LiDAR Quality Assessment Report

SC_AikenCo_2012_Apr2013

Six County SC Lidar, Aiken County

Aiken County Final Review, USGS Contr...

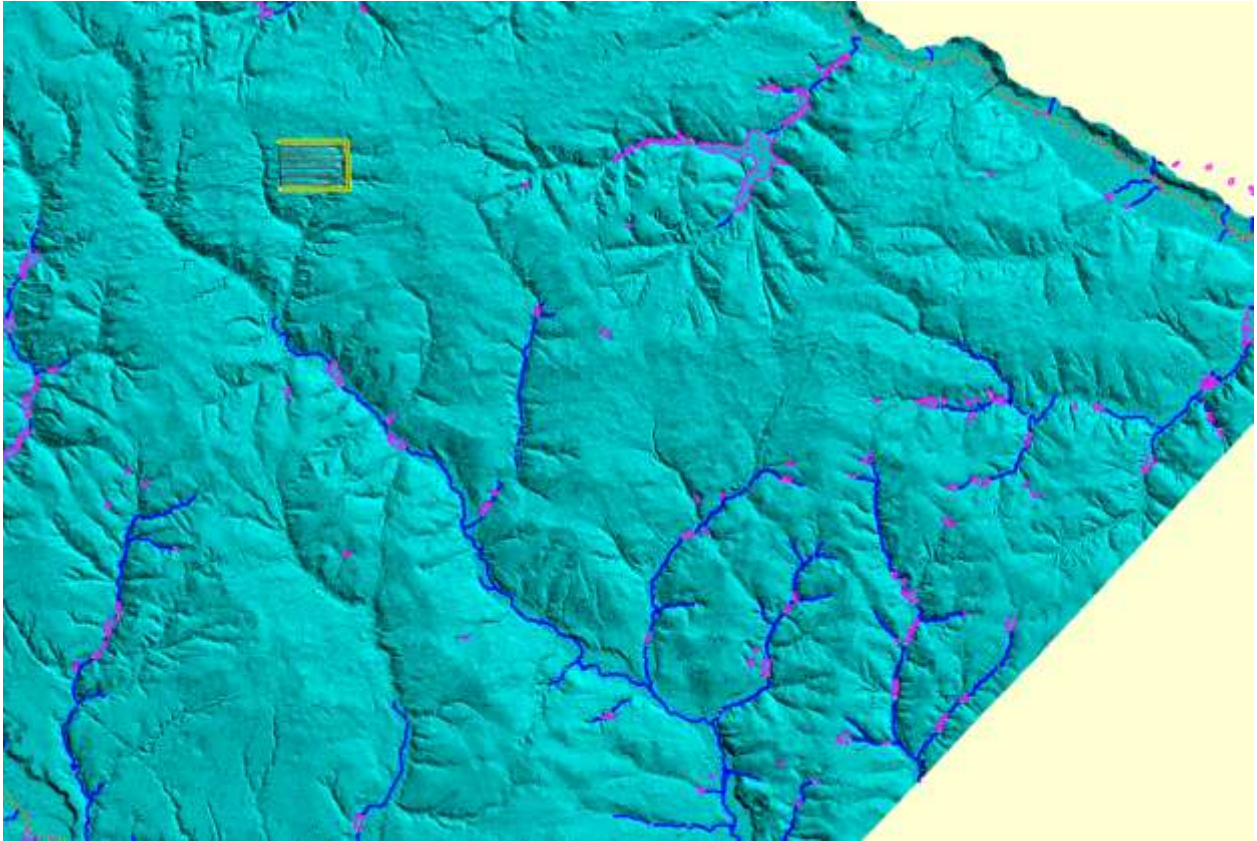
The box represents a 1/2 sq mile, Blue lines are hydro breaklines. Per the Task Order, Hydro Breakline Specifications, Hydro feature data capture requirements; "Hydro breaklines will be captured for drainage features that drain approximately 1/2 sq mile or more." The shortage of these breaklines seems typical in many areas of the county.

Typical Pits at Connector

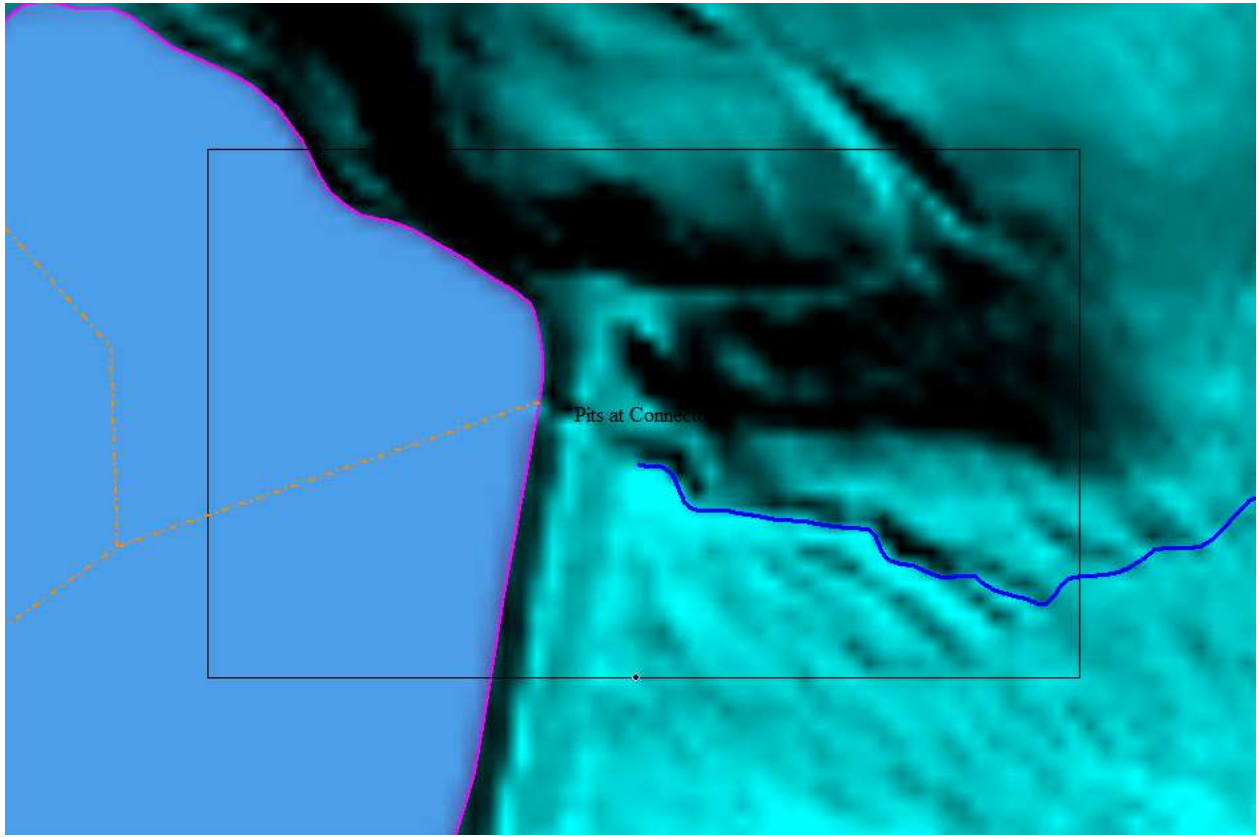
These Pits are still prevalent in the 8/6/2014 data.

Several Pits at Connectors

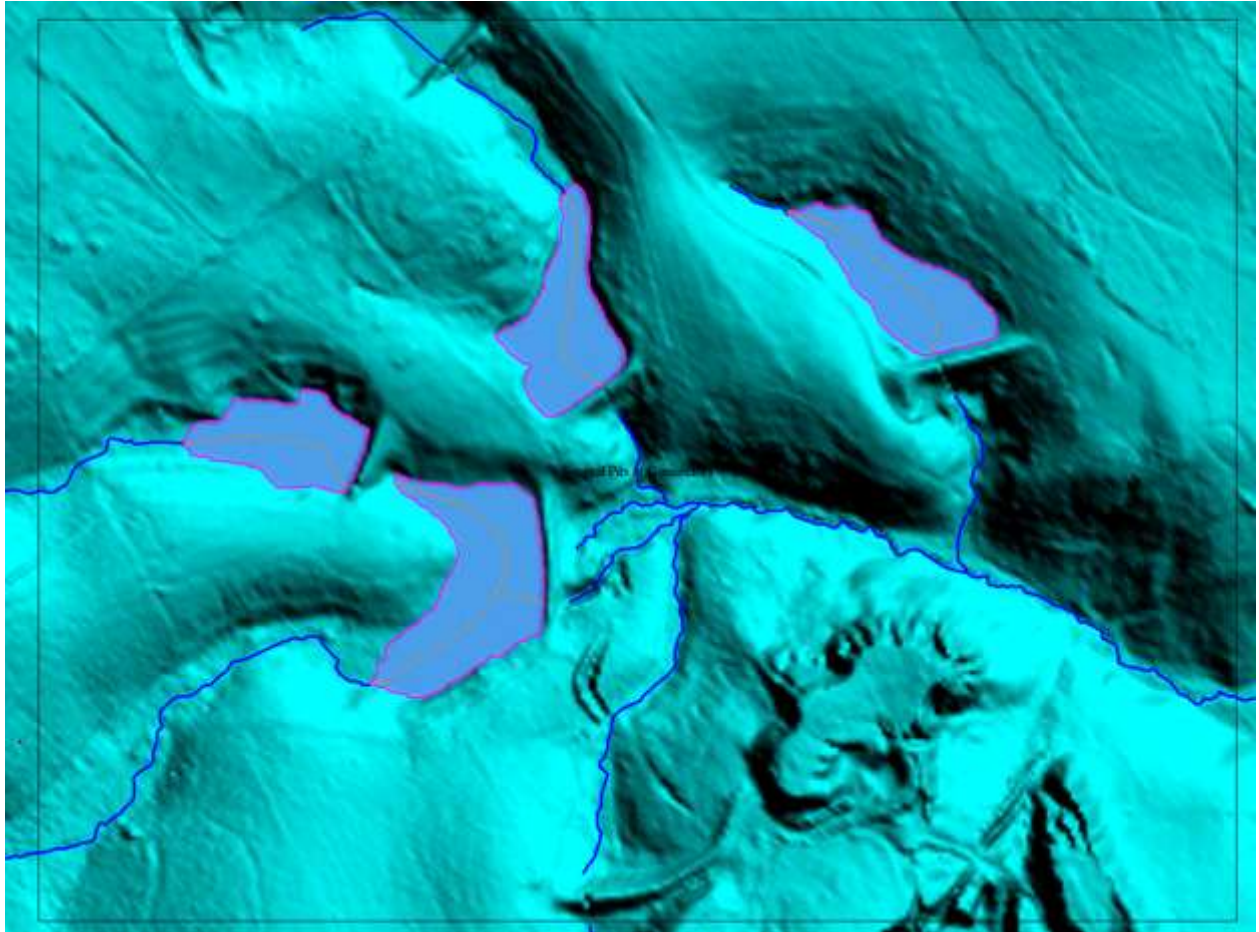
These Pits are still prevalent in the 8/6/2014 data.

Typical Pits at Culvert

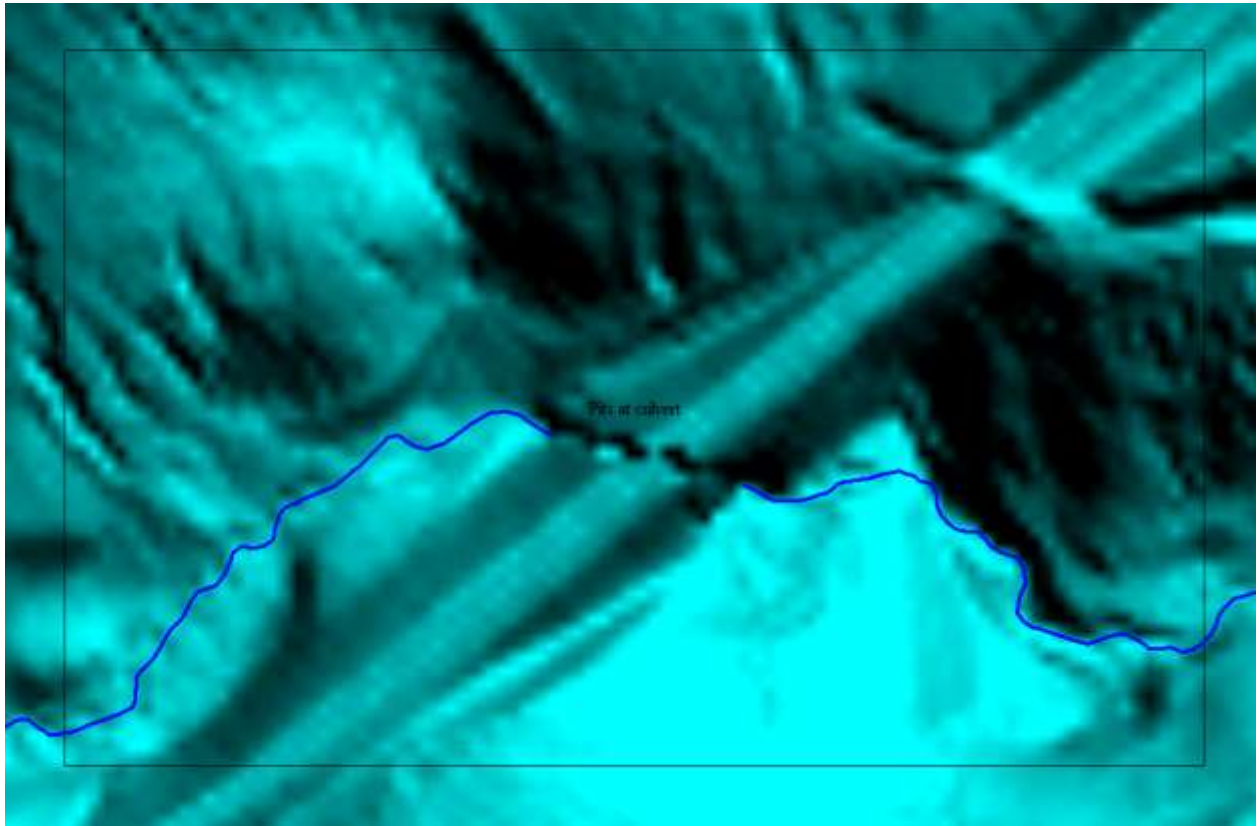
These Pits are still prevalent in the 8/6/2014 data.

Typical Pits at Culvert

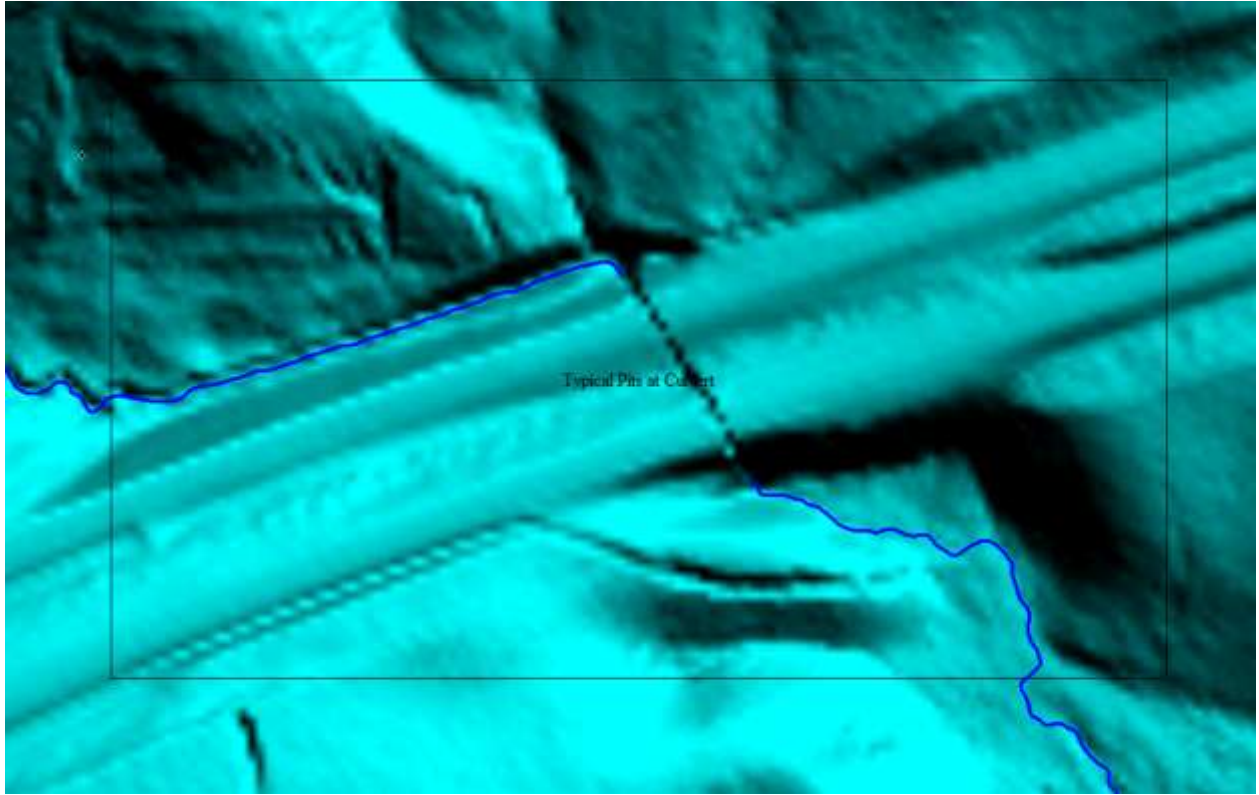
These Pits are still prevalent in the 8/6/2014 data.

Typical Pits at connector

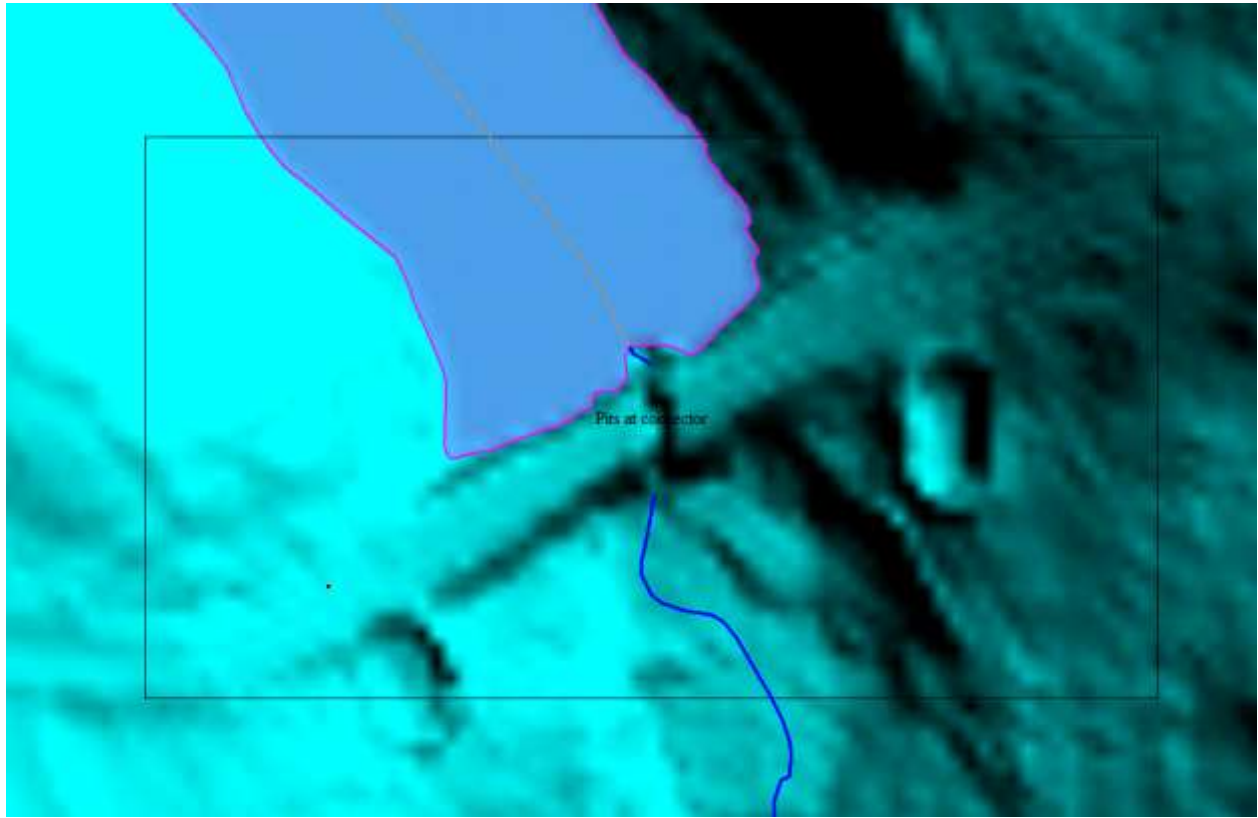
These Pits are still prevalent in the 8/6/2014 data.

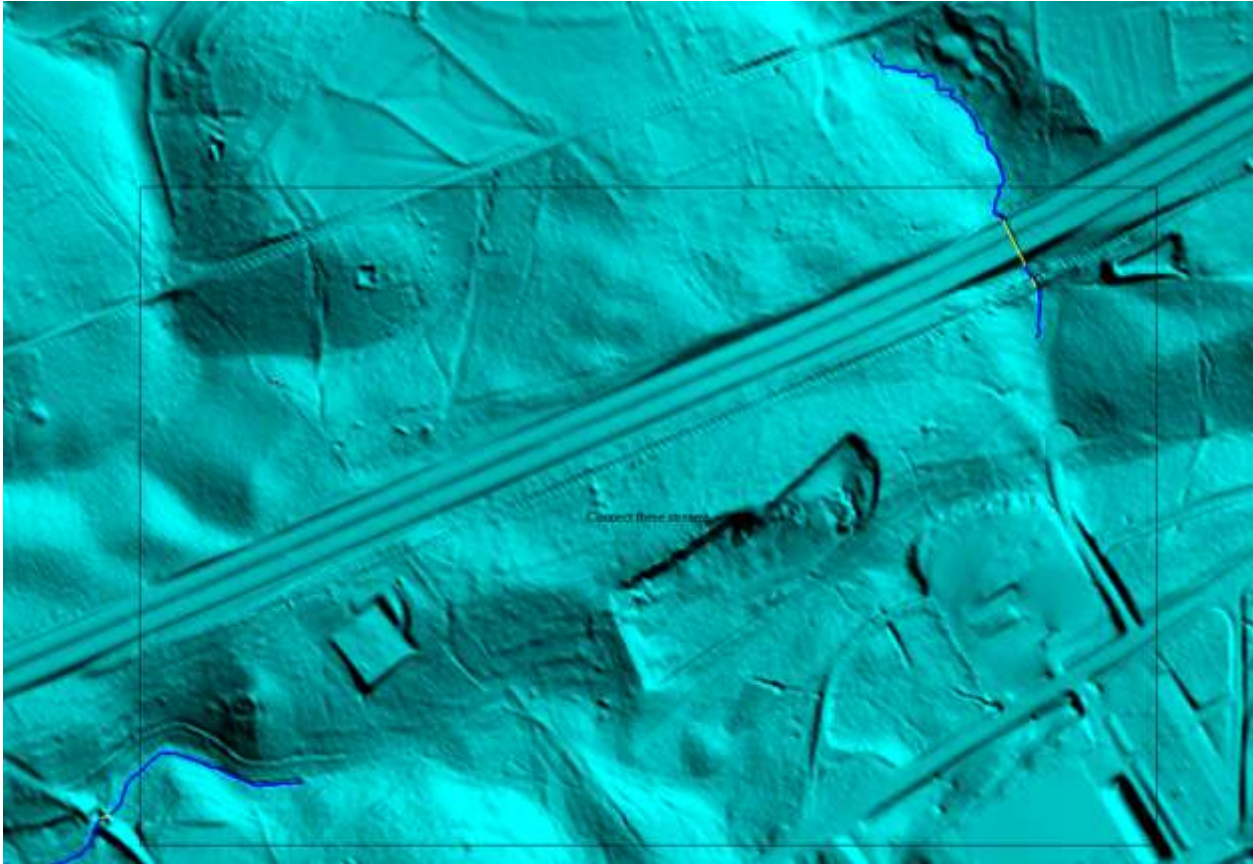
Connect these streams? Many of the smaller stream disconnects were connected. Some streams, with much larger gaps, still appeared to need to be connected. These streams stopped without appearing to flow into another lake, river, or stream. If this is correct, there should be mention of losing streams in the reports and the metadata.
